Docket No. 50-423

Millstone Nuclear Power Station, Unit No. 3,
Revision to Reference (1); Reporting of a
Potential Significant Deficiency in the
Design of the Service Building and Auxiliary Building

Millstone Nuclear Power Station, Unit No. 3

Figures 1-4 Auxiliary Building Revisions

FIGURE 1

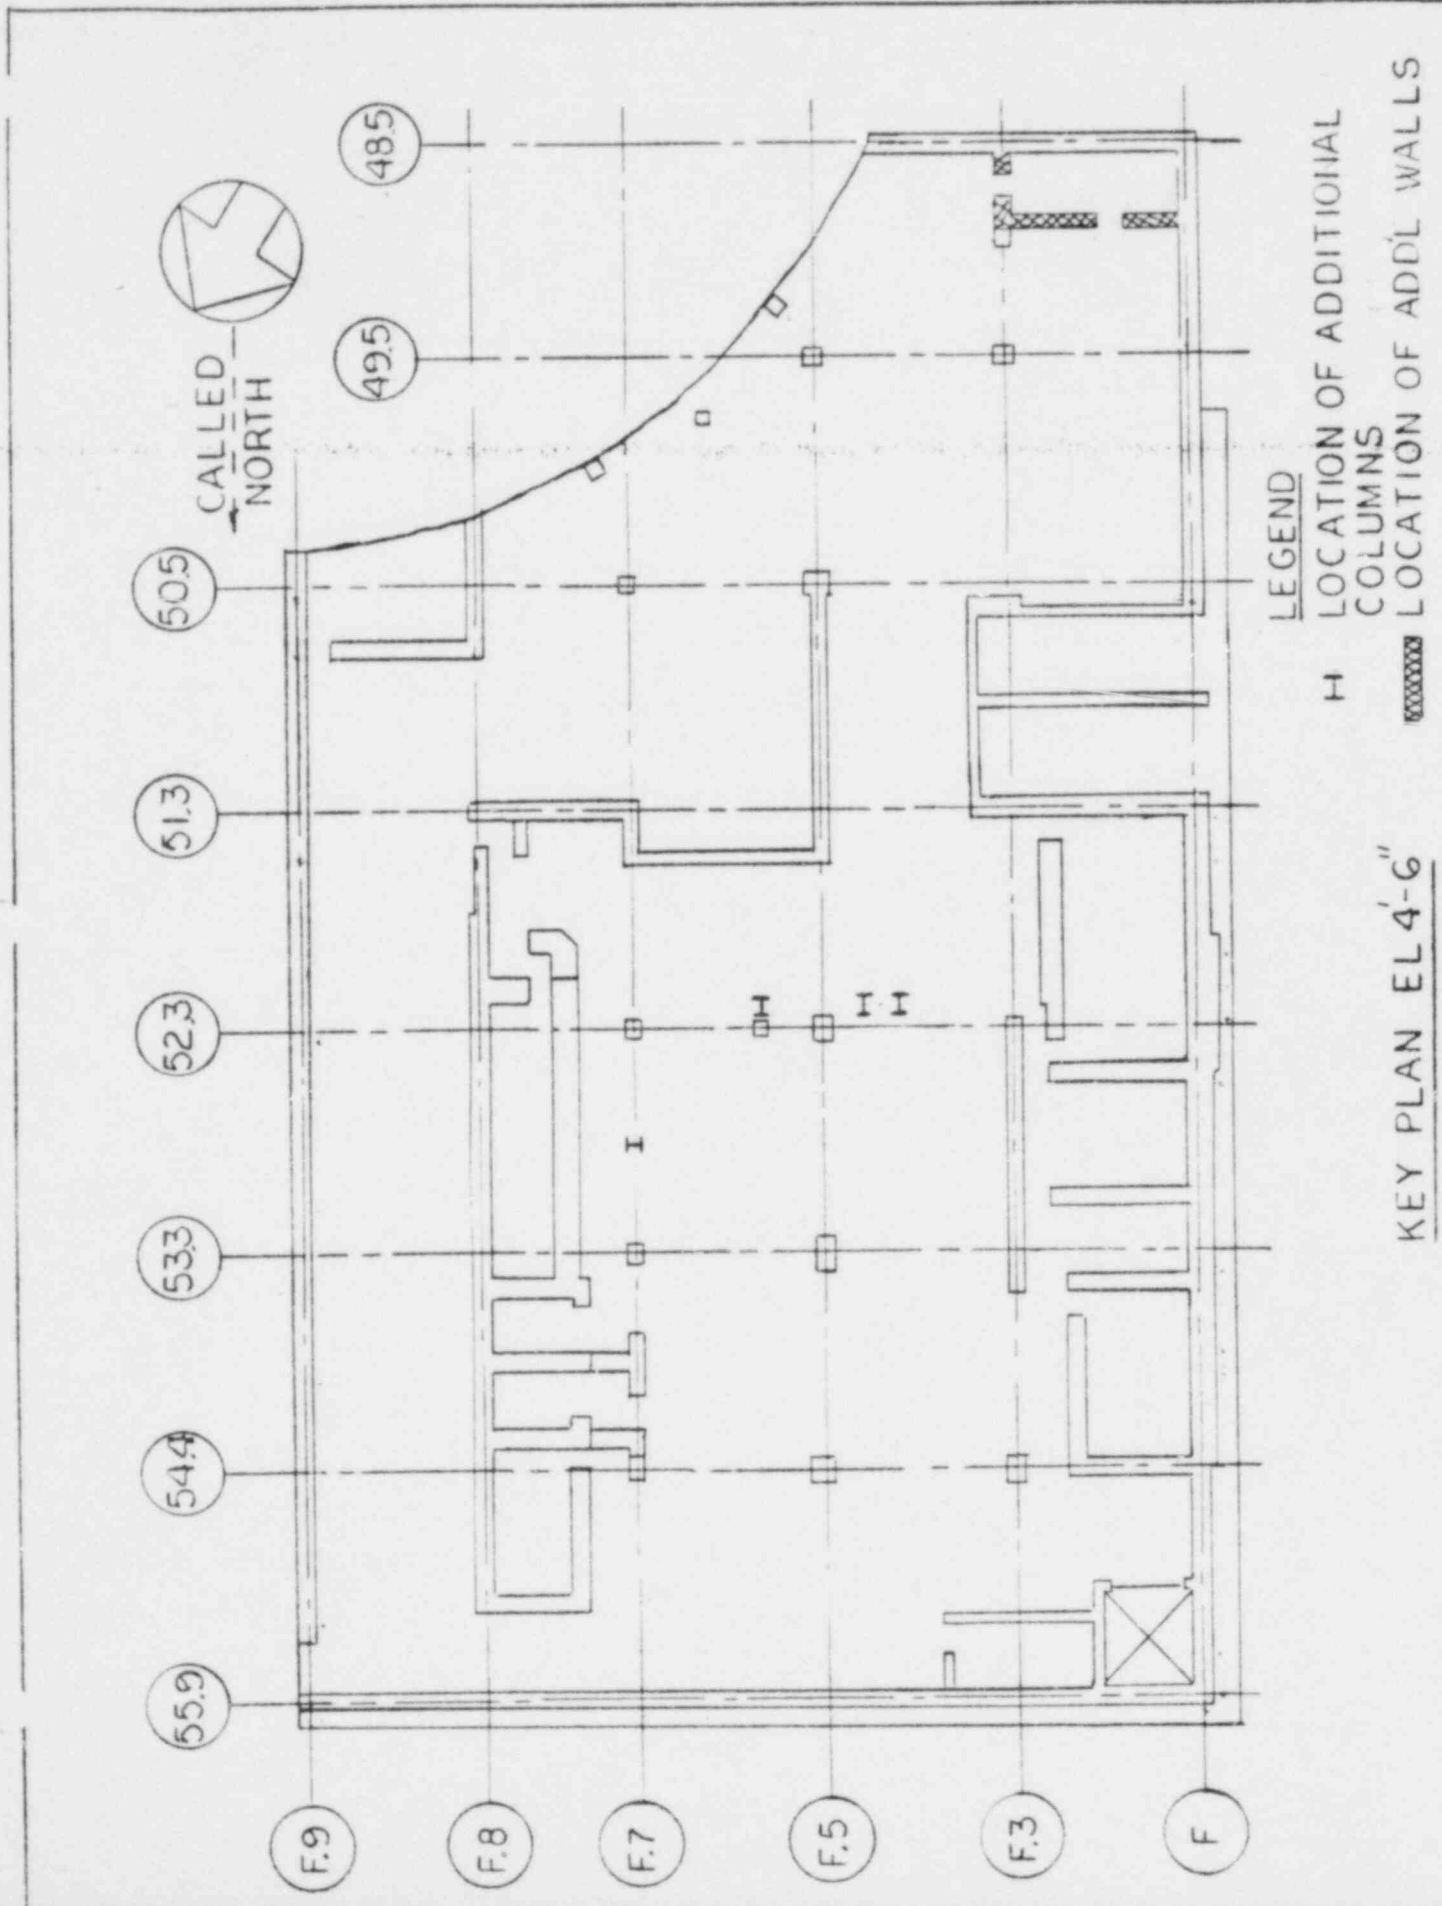
Figure 1 Additional Columns between elevation 4'-6" and 24'-6".

- o Four I-Section columns are shown instead of the three square columns originally shown. The use of steel columns was decided upon instead of reinforced concrete. At one location an interface required the use of two columns instead of one.

- o Between 48.5 and 49.5, lines F and F.3, there are additional walls shown with access openings. These were found structurally necessary.

FIGURE 2

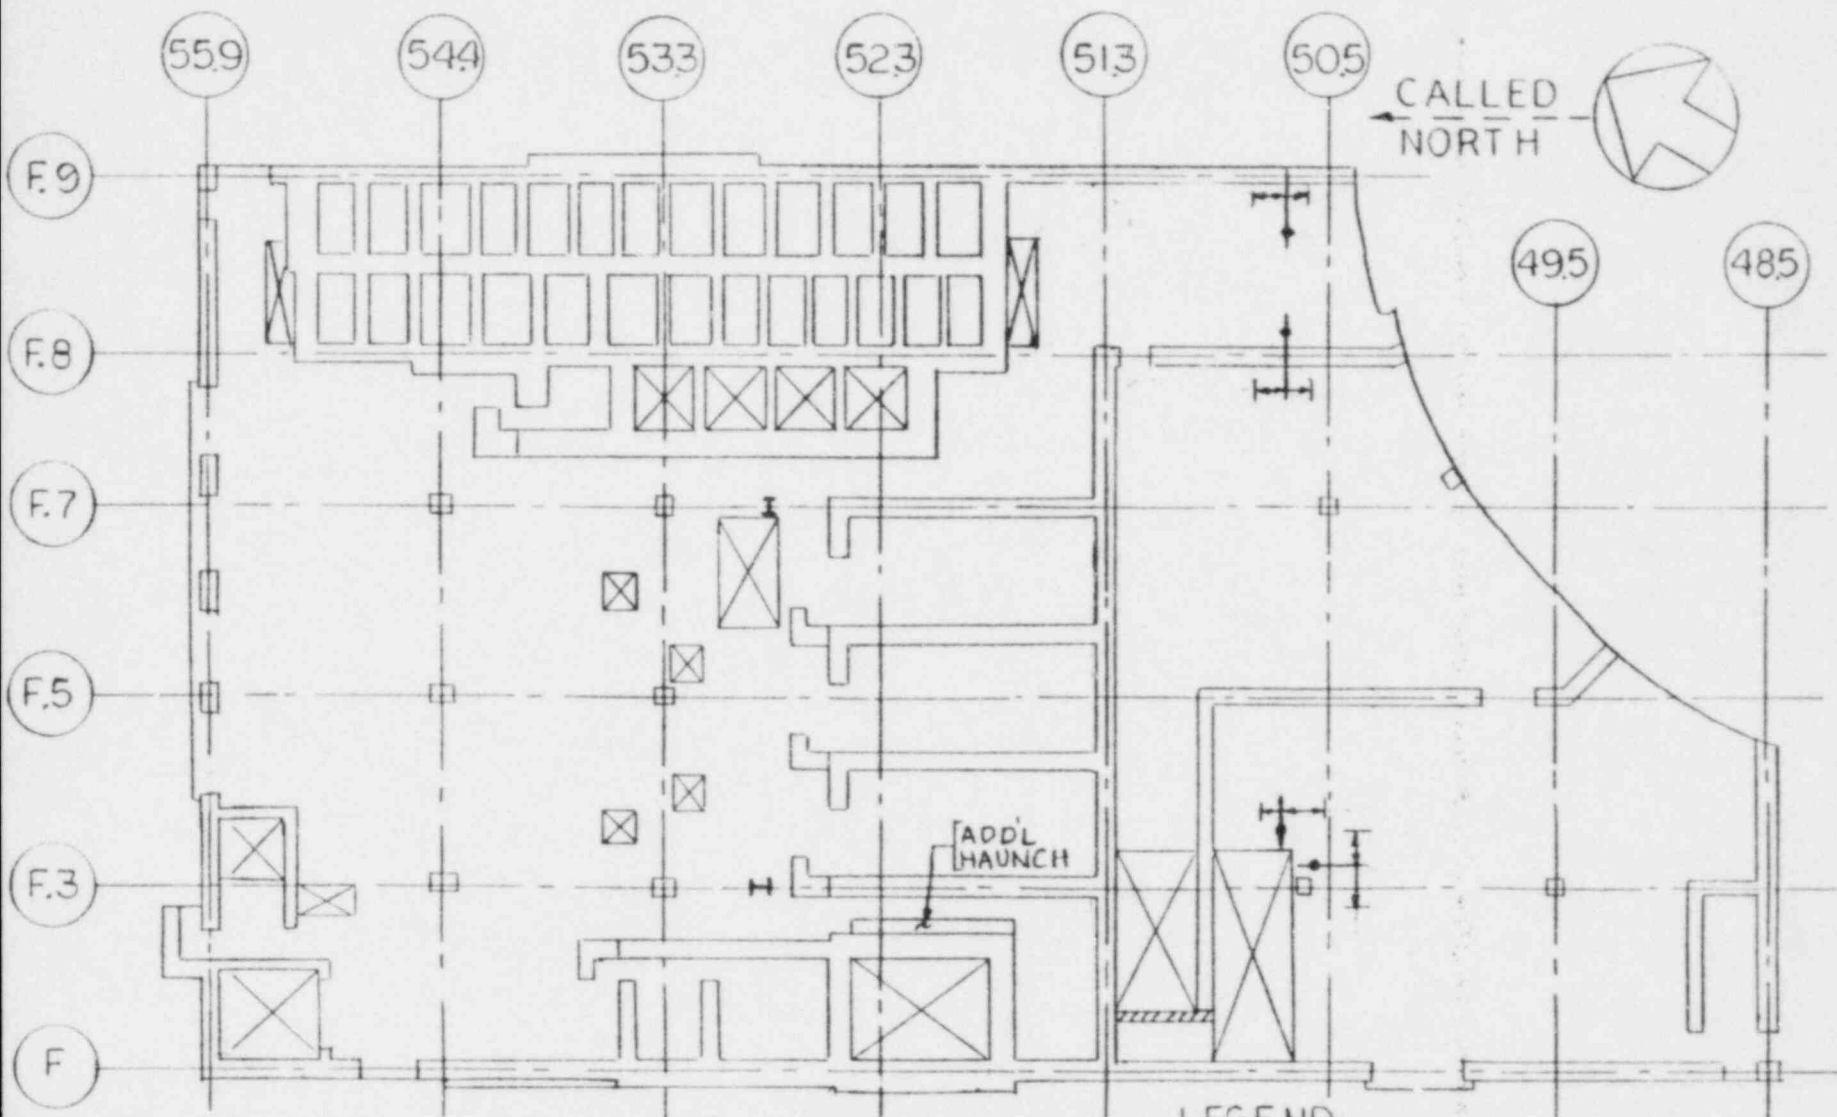
Figure 2 Elevation 24'-6" to 43'-6"

- o Between 52.3 and 53.3, lines F.3 and F.7 the final columns used were steel sections. Originally only square columns were indicated.
- o Between 51.3 and 53.3, close to F.3 line, structural considerations required the addition of a reinforced concrete haunch.

FIGURE 3

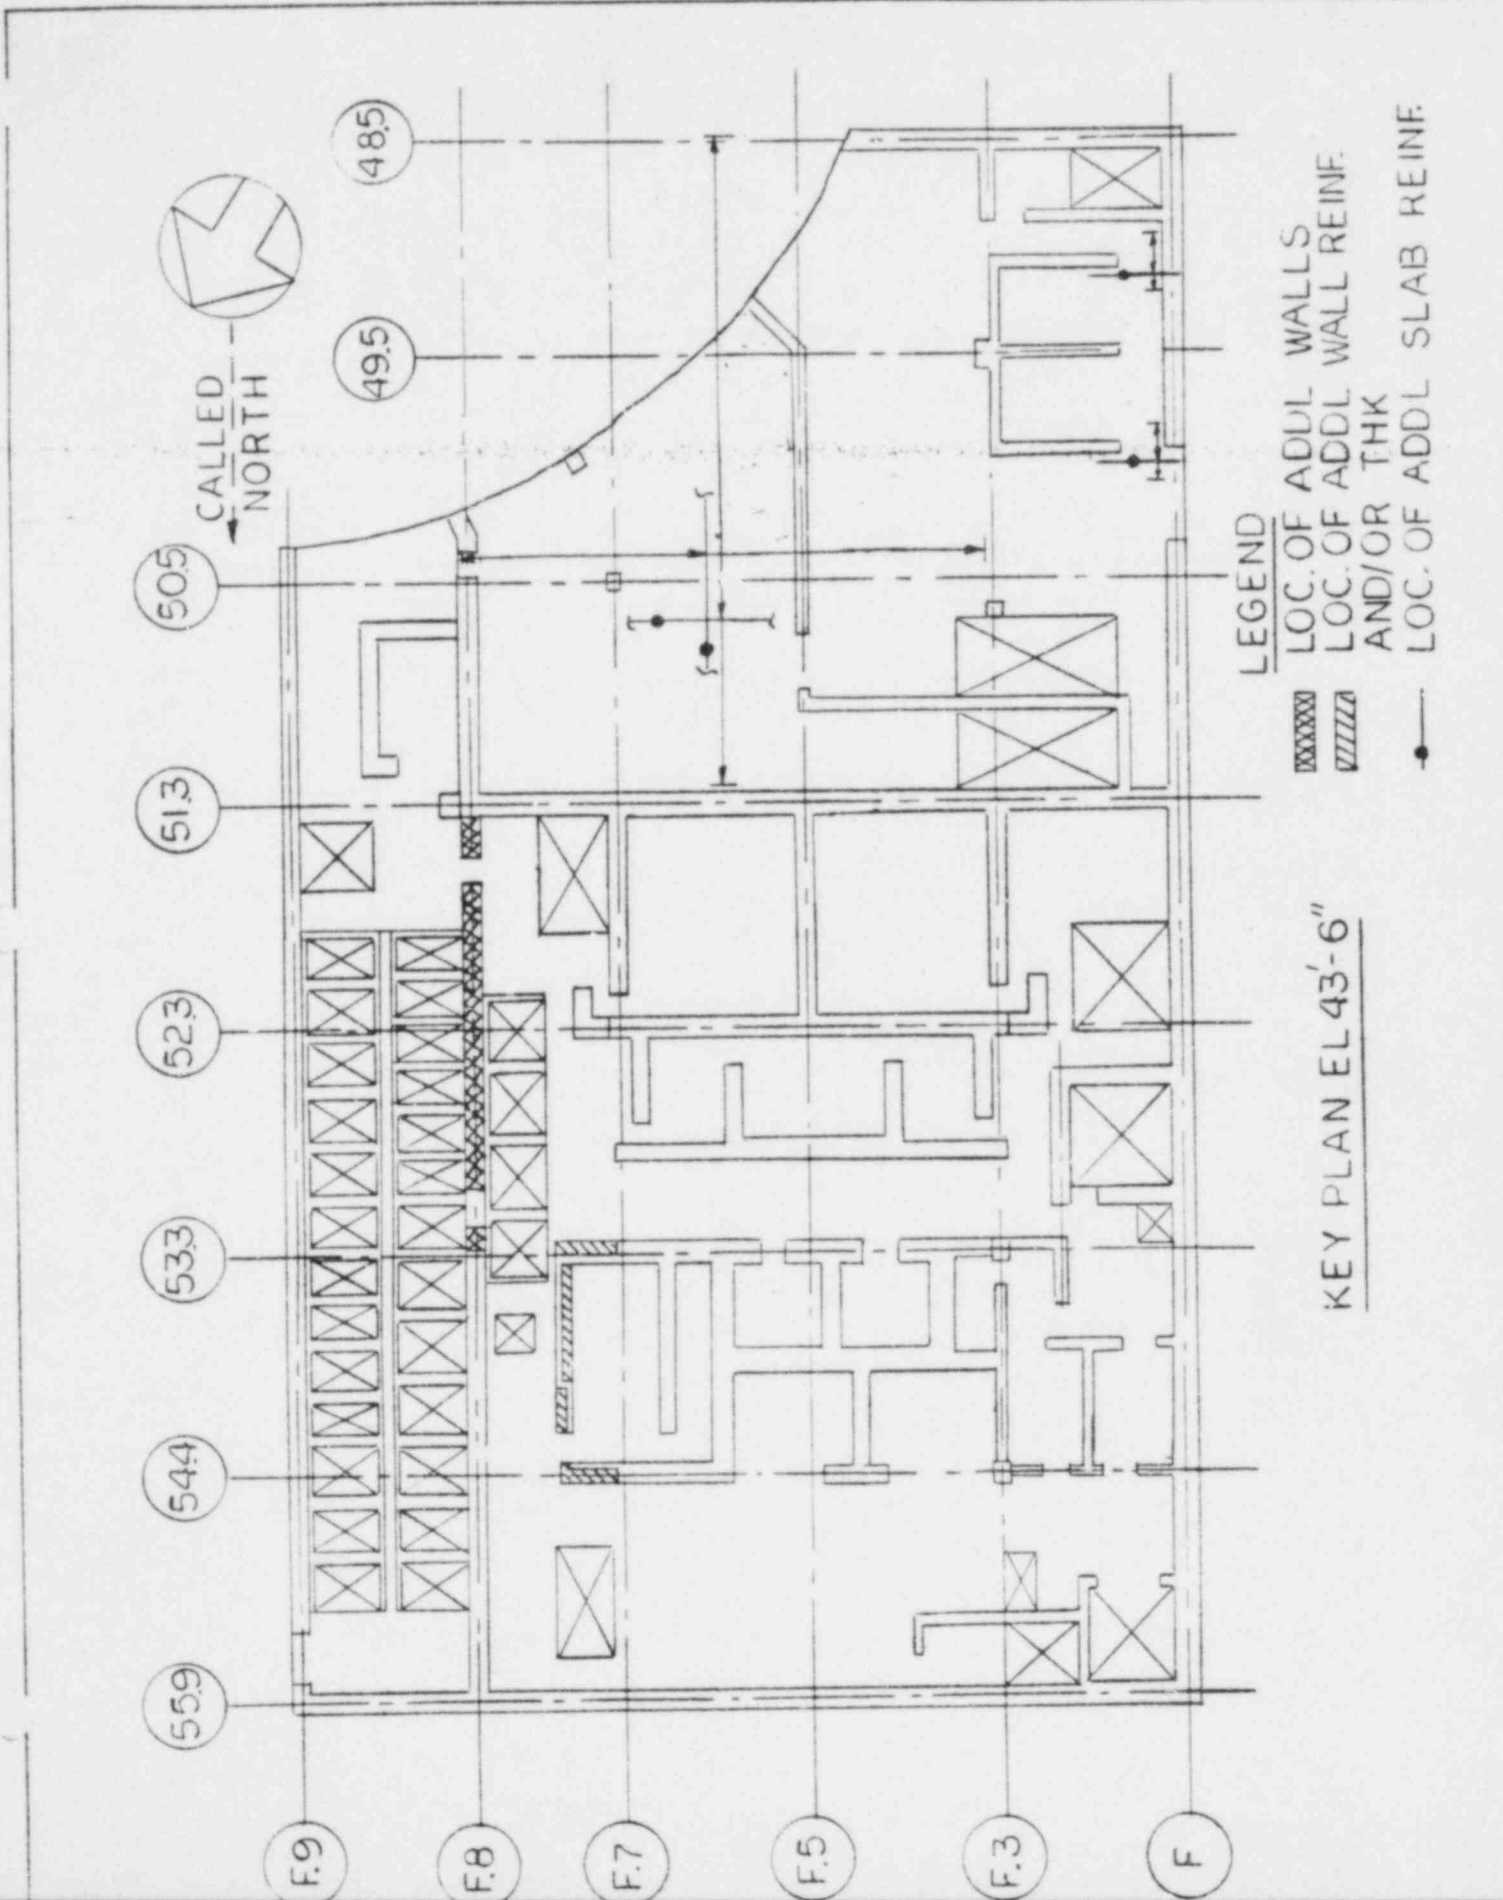
Figure 3 Elevation 43'-6", wall along F.8 line

- o Wall access openings were added as shown.

FIGURE 4

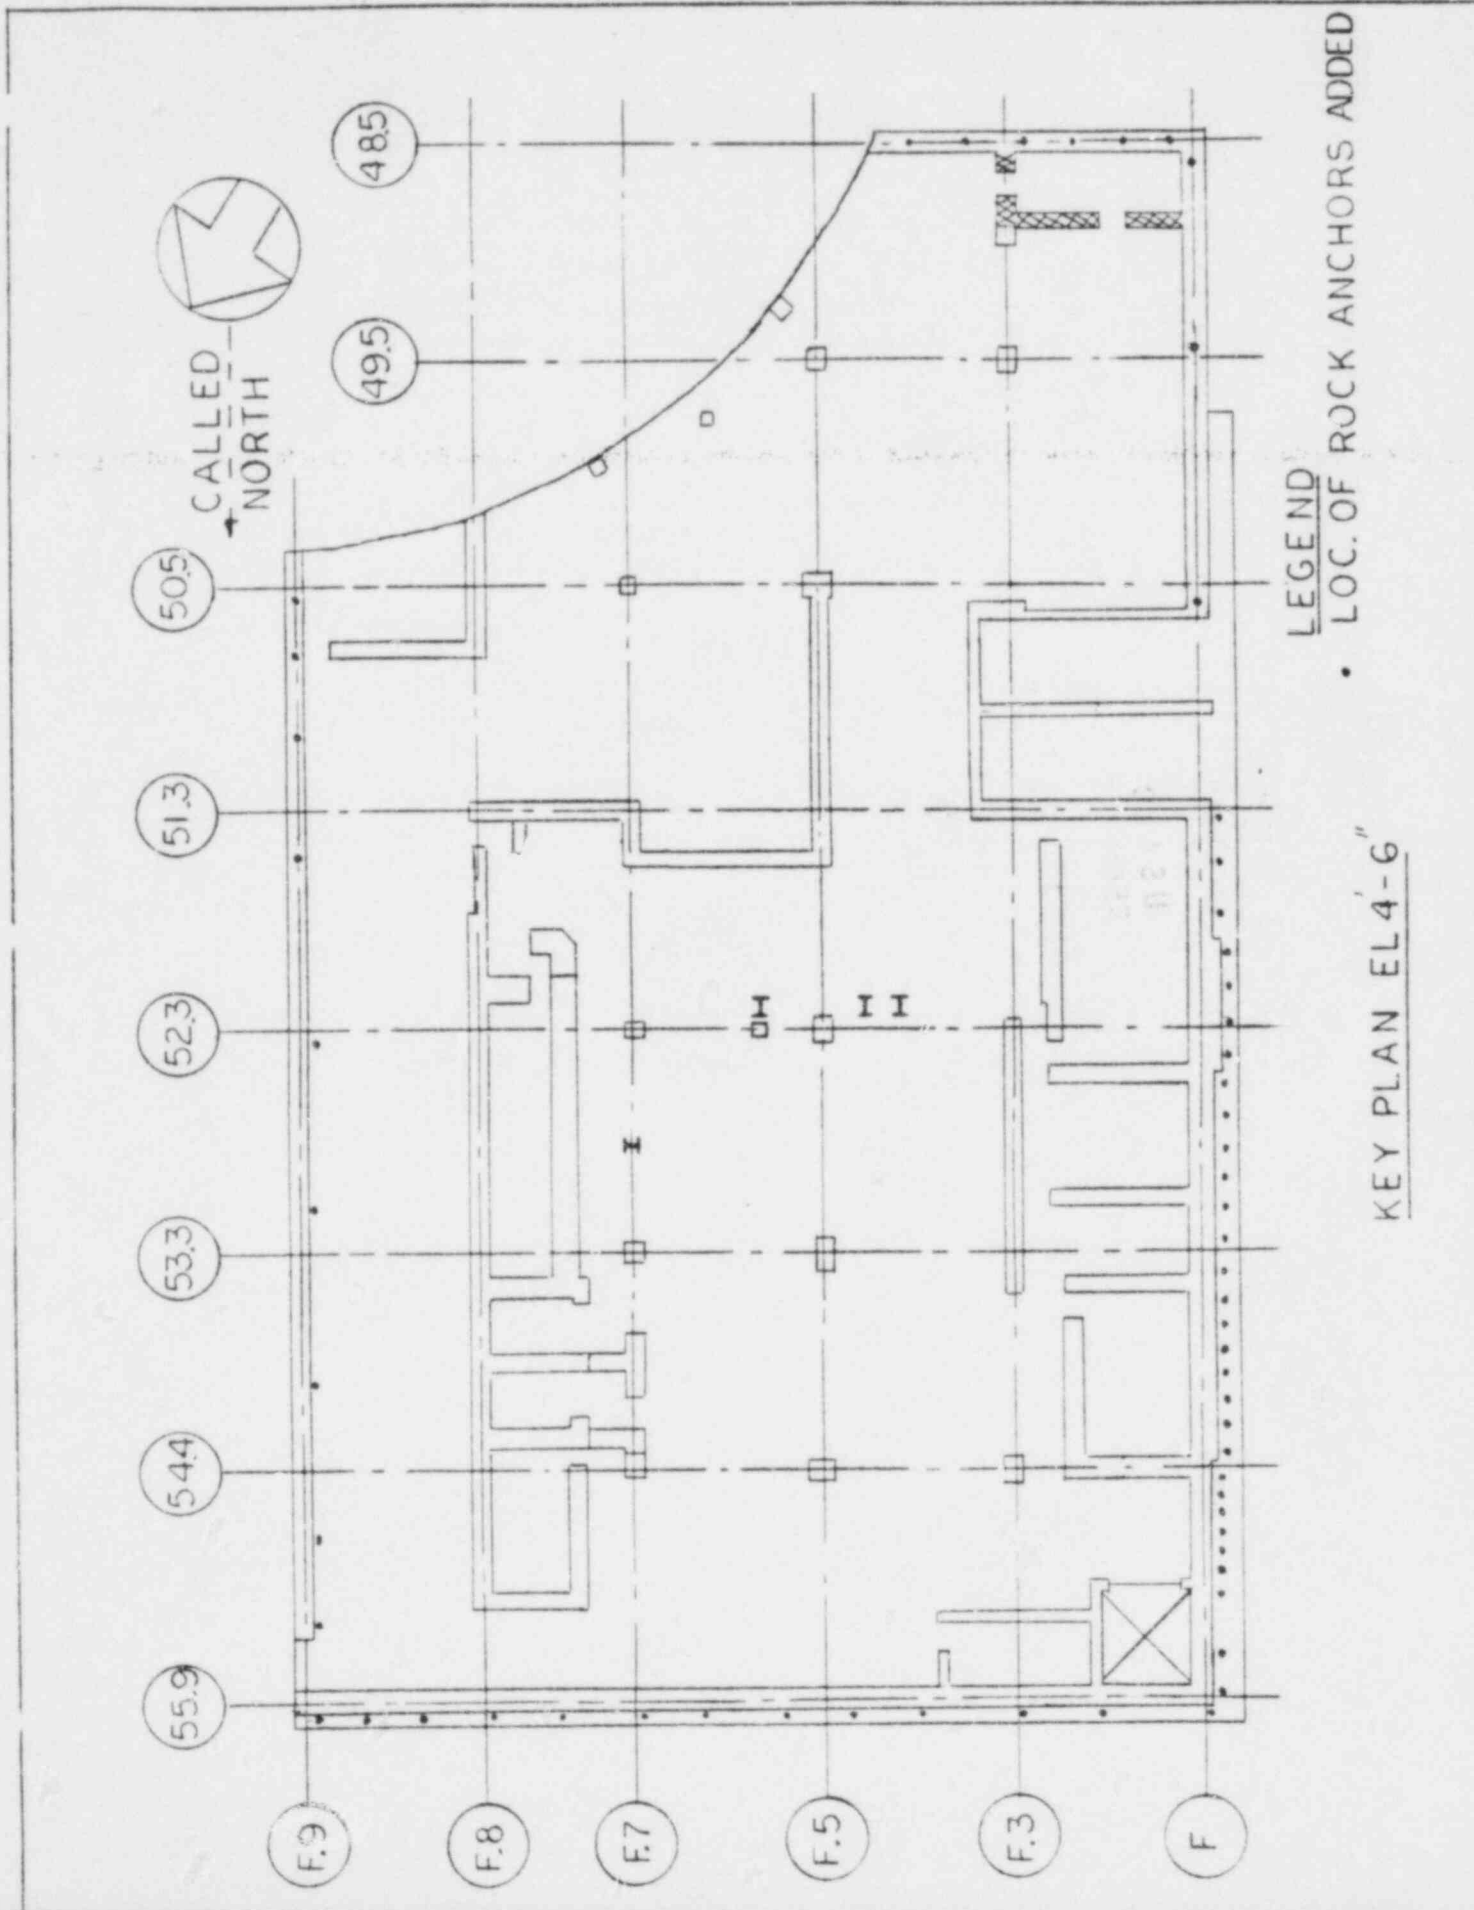
Figure 4 Elevation 4'-6", locaton of rock anchors

- o The individual locations shown represent the actual modifications made.
